ACCESS REPORT

SECTION 75W APPLICATION

RACECOURSE PL, EVANS AVE & BARBER AVE EASTLAKES TOWN CENTRE NORTH

MIXED RESIDENTIAL / RETAIL DEVELOPMENT

External Pathway Links and Building Entrances (Parts D3.2 & D3.3 of the BCA)

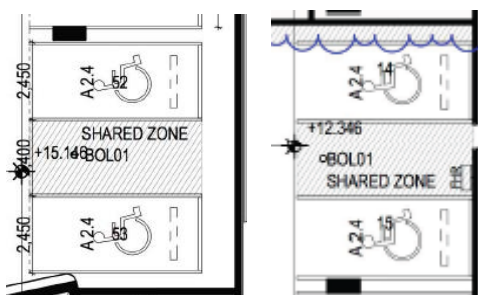
BCA / DDA Compliance	Complies
<p>I. Street Frontage Retail & Common Domain Entrances – The development proposes multiple pedestrian site entrances including the following;</p> <ul style="list-style-type: none"> (a) North side of the development provides a central 1:40 gradient walkway from Evans Avenue @RL18.540 to the Mall North @RL18.700 which facilitates access to the retail areas. (b) Evans Avenue also provides direct on-grade generally level entry to a residential lift lobby where lifts 21 and 22 access Building 1B, which proposes a common lobby that enables all residents to access the podium area and accessways to buildings I and 1A. 	<p>YES</p> <p>YES</p>

BCA / DDA Compliance	Complies
2. With respect to the actual entrances into the street frontage retail tenancies there will be generally level access with several providing 1:8 threshold ramps, which will be detailed to be 35mm maximum rise and 280mm maximum length in accordance with ASI428.1 to comply and satisfy D3.2 of the BCA	YES at CC Stage

Parking (Part D3.5 of the BCA)

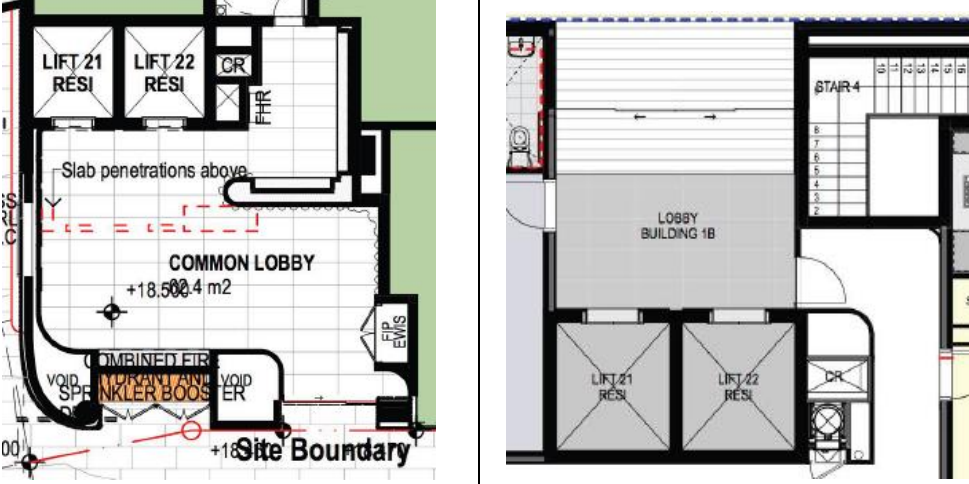
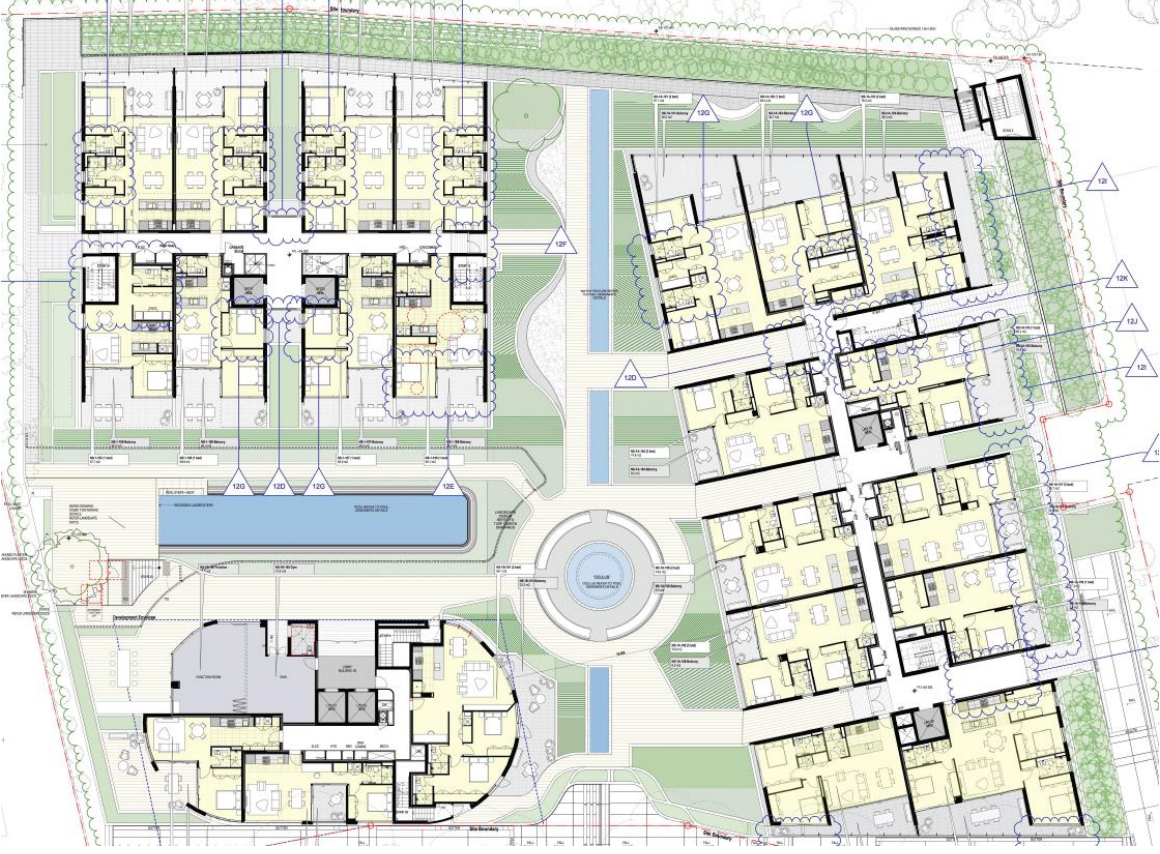
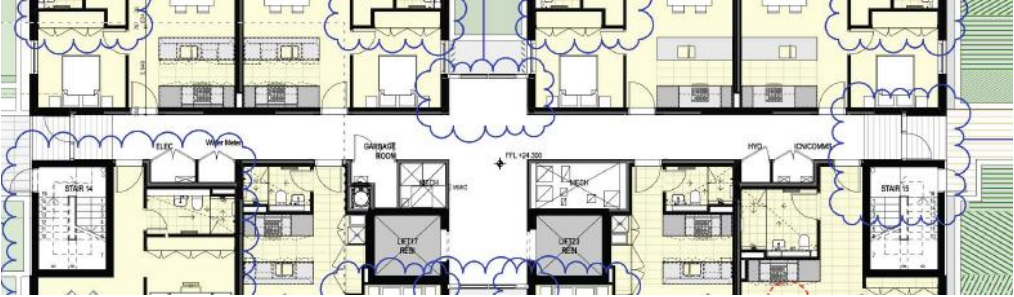
BCA / DDA Compliance	Complies
3. 290 parking spaces within a three level basement car park including 15 accessible spaces (4 retail and 11 for the adaptable apartments).	YES
4. With respect to accessible parking , the plans proposes 2400mm width spaces adjoining a 2400mm shared area to enable transfers in and out of vehicles by people with mobility aids in accordance with AS2890.6.	YES
5. The car park shall provide 2200mm minimum height entry and aisle height and 2500mm height over the accessible spaces in accordance with AS2890.6	YES

Internal Accessways (Part D3.3 of the BCA)

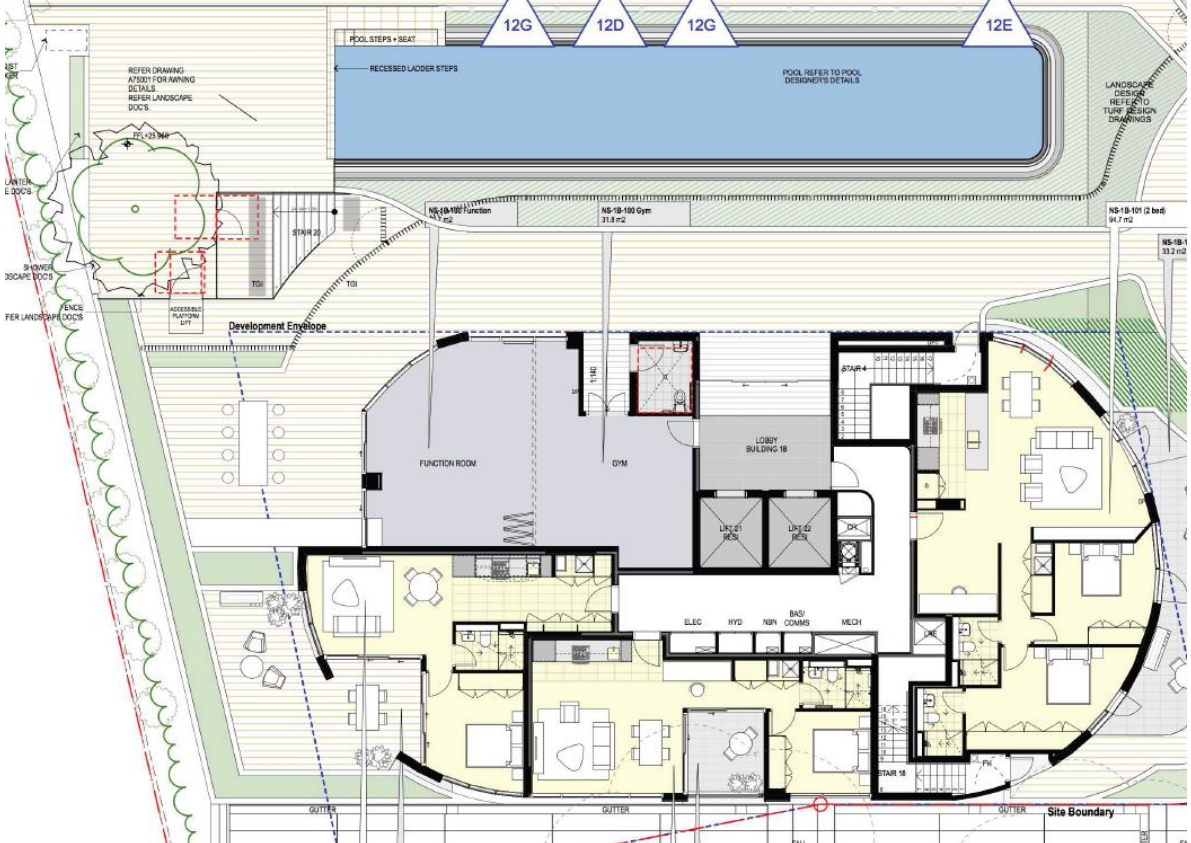
BCA / DDA Compliance	Complies
6. Ground Floor Retail - The ground floor retail areas shall provide an open plan layout across a single level @RL18.700 for the South Mall areas enabling access to all areas in accordance with ASI428.1 and Part D3.3 of the BCA.	YES

7. Future DA's shall be prepared relating to the internal fitouts of these areas.	YES at CC stage
8. The ground floor retail area proposes a 1500-1800mm width accessway to communal sanitary facilities which enables turning and passing in accordance with ASI428.1 and satisfy Part D3.3 of the BCA.	YES

9. The retail area incorporates a lift and travelator from the basement parking levels to the ground floor to ensure equitable access to satisfy Part D3.3 of the BCA.	YES

10. Doors and Door Hardware - The construction documentation shall confirm 920mm minimum doors (butt hinge) providing 850mm clear opening width with lever handles, 20 N maximum force to open doors, which have appropriate luminance contrast to adjoining walls and level thresholds in accordance with ASI428.1 to satisfy Part D3.3 of the BCA.	YES at CC stage

Building IB – 6 X 2 bedroom apartments on levels 2, 3, 4, 5, 6, 7.

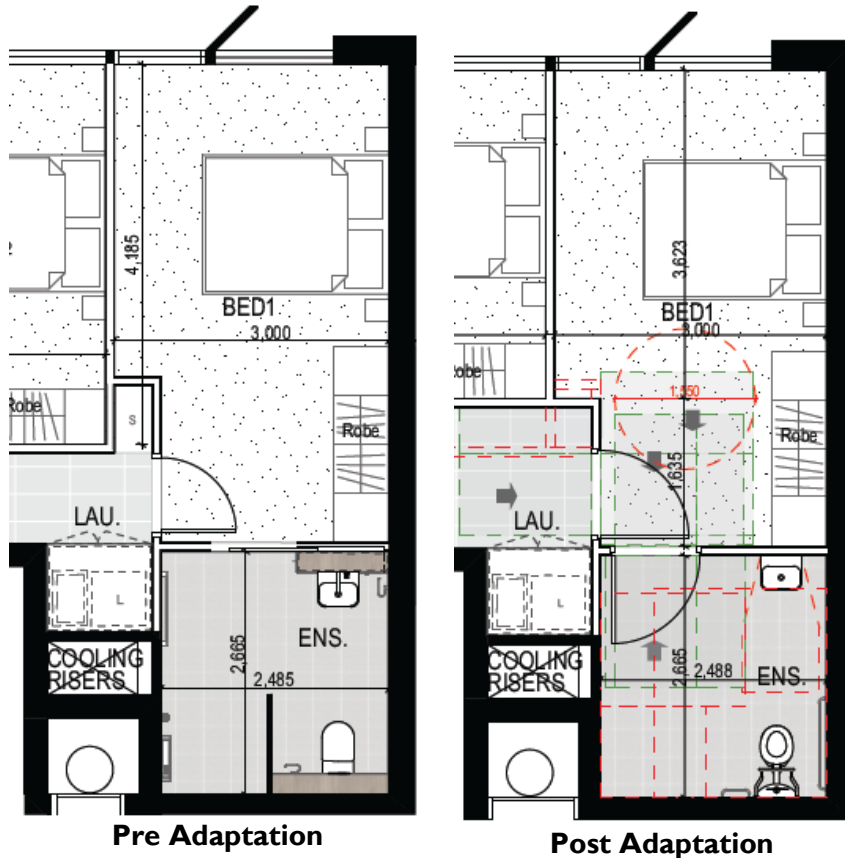
Clause	Adaptability Assessment	Compliance
AS4299 Clauses 3.3 and 3.5	<p>Common Resident Entry Lobbies – Section A describes the site accessways to all residential apartments which confirms equitable access to the adaptable units in accordance with AS1428.1 to satisfy Parts D3.2/D3.3 of the BCA and Council’s Access DCP.</p> <p>Overall I am satisfied that the principal building entrances and access to the lifts will provide appropriate access for people with disabilities in accordance with AS1428.1 / AS4299.</p>	YES
AS4299 Cls 3.3.3, 3.7 & AS2890.6	<p>Car Parking</p> <p>The plans shown eleven (11) accessible car spaces within the Basement 2 and 3 parking levels to be allocated to the adaptable apartments.</p> <p>With respect to accessible parking designs, the plans propose 2400mm width spaces adjoining a 2400mm shared area to enable transfers in and out of vehicles by people with mobility aids in accordance with AS2890.6 and the intent of AS4299.</p> <p>The car park shall provide 2200pmm minimum height entry and aisle height and 2500mm height over the accessible spaces in accordance with AS2890.6 and the intent of AS4299.</p>	<p>YES</p> <p>YES</p> <p>YES</p>

AS4299 Clause 3.8	<p>Letterboxes</p> <p>The development will provide the letter boxes within the residential lift lobby and will provide at least 1550mm X 1550mm level landing areas in front of all letter boxes for circulation and access to comply with AS4299.</p>	YES at CC stage
Part E3.6 of the BCA	<p>Lift Access</p> <p>The plans indicate the lift cars will be at least 1400mm X 2000mm to satisfy Part E3.6 of the BCA and Council’s Access DCP and will be detailed to comply with AS1735.12 – <i>Lifts For People With Disabilities</i>.</p>	YES

Clause	Adaptability Assessment	Compliance
AS4299 Clauses 4.3.1, 4.3.2 and 4.3.3	<p>Accessible entry – The front entrances to these units provide a level threshold and a doorway with 850mm clear opening width.</p> <p>With respect to doorway circulation spaces the plans show the required 1600mm X 1600mm externally in the common corridors and internally with 530mm minimum latch side clearance with a 920mm min entry door, as specified by AS4299.</p>	<p>YES</p> <p>YES</p>
AS4299 Cls 4.3.7	<p>Interior: general – The pre adaptation plans provide open plan living areas with direct access to the main bedroom doorways in accordance with AS1428.1/4299.</p> <p>Doors and Door Hardware While the plans do not indicate 920mm external door widths, 870mm internal door widths and lever handles these details should be provided at construction drawing stage to confirm compliance.</p>	<p>YES</p> <p>At CC Stage</p>

AS4299 Clause 4.7	Living and Dining rooms – The plans show combined living and dining area on a single level with sufficient area to provide a 2250mm diameter turning area to comply with this clause.	YES
AS4299 Clause 4.5	<p>Kitchen – The kitchen pre adaptation plans provide the required 1550mm minimum circulation space adjacent to the benches and appliances to comply with AS4299 requirements.</p> <p>With regard to the “adaptability” of the kitchen the pre-adaptation plan provides an appropriate layout of sink, fridge, wall oven, cooktop while the post adaptation plan proposes a height adjustable workbench that is readily adaptable and satisfies the “ease of adaptation” guidelines outlined in section 2 – Performance Objectives of AS4299.</p> <p>Therefore, subject to confirmation of the installation of kitchen cupboards, appliances and the like at the construction documentation stage it is apparent that the kitchen will comply with AS4299.</p>	<p>YES</p> <p>YES</p>

AS4299 Clause 4.6	<p>Main bedroom – The plans show the main bedroom for;</p> <ul style="list-style-type: none"> Building 1B - 6 X 2 bedroom layout will be at least 3000mm x 5250mm providing 1540mm X 2070mm circulation space at the side of the bed and a 1000mm-1200mm on the other sides of the queen sized bed with appropriate doorway circulation spaces to enter/exit the room and access the robe area to satisfy AS4299/1428. 	YES

Bathroom – The post adaptation plans show the bathrooms for the adaptable unit type will be at least 2480mm X 2660mm which provides ample area to comply with AS1428.1/4299.

The construction certificate plans shall confirm an appropriate layout of sanitary facilities with dual plumbing services for the toilet relocations and shower/basin modifications to comply with AS1428/4299 to satisfy the performance requirements of AS4299.

Toilet – With respect to the provision of visitable toilets the plans indicate that the abovementioned adaptable bathrooms will provide a design with a size and layout that enables the toilet to comply with AS4299 by providing 1250mm X 900mm in front of the WC pan.

Laundry – The laundry facilities provide adequate space for a washing machine/drier while the adjacent area facilitates the required minimum 1550mm X 1550mm clear circulation space in front of the appliances to comply with AS4299.

Garbage – The plans illustrate a garbage chute on each floor that is adjacent to a 2000mm width common corridor, which provides appropriate access to comply with AS1428.1 and satisfy Table D3.1 and Part D3.3 of the BCA.

Clause	Adaptability Assessment	Compliance
AS4299 Cls 3.5(b)	<p>Outdoor Private Open Space – The plans show outdoor balcony terrace areas of 11sqm adjacent living areas for each of these units with sliding doors for convenient access and an approximate, which provide at least 1500 X 2800, which is adequate to perform a 180 degree wheelchair manoeuvre.</p> <p>While the plans do not indicate thresholds the construction drawings will confirm the capability for installing in-fill decks and 35mm height threshold ramps over sliding door tracks to comply with AS1428/4299.</p>	YES
